STAFF REPORT 11-13-2019 MEETING
APPLICATION NUMBER 19-6464
ADDRESS: 4801 STURTEVANT
HISTORIC DISTRICT: RUSSELL WOODS - SULLIVAN
APPLICANT: WAYNE GROLEAU
DATE OF APPLICATION: 9-23-2019
DATE OF VIOLATION: 9-26-2019
DATE OF STAFF VISIT: 11-6-2019

PREPARED BY: B. CAGNEY

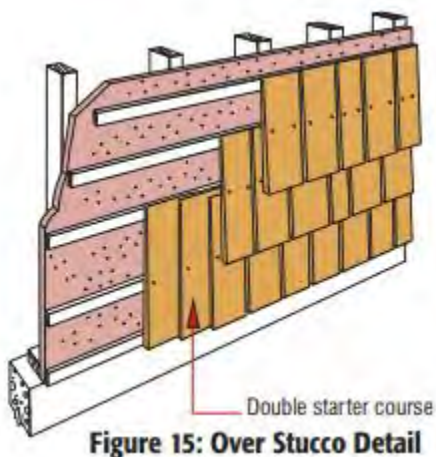
We don't agree on whether the wood shakes at rear were salvageable

Why would I spend all this money and time if I could just paint the existing shakes?

It is also true that appearance is important according to section 5.(3)(d) "Other factors, such as aesthetic value, that the commission finds relevant." The aesthetic value of a non original rotted shake is not too good.
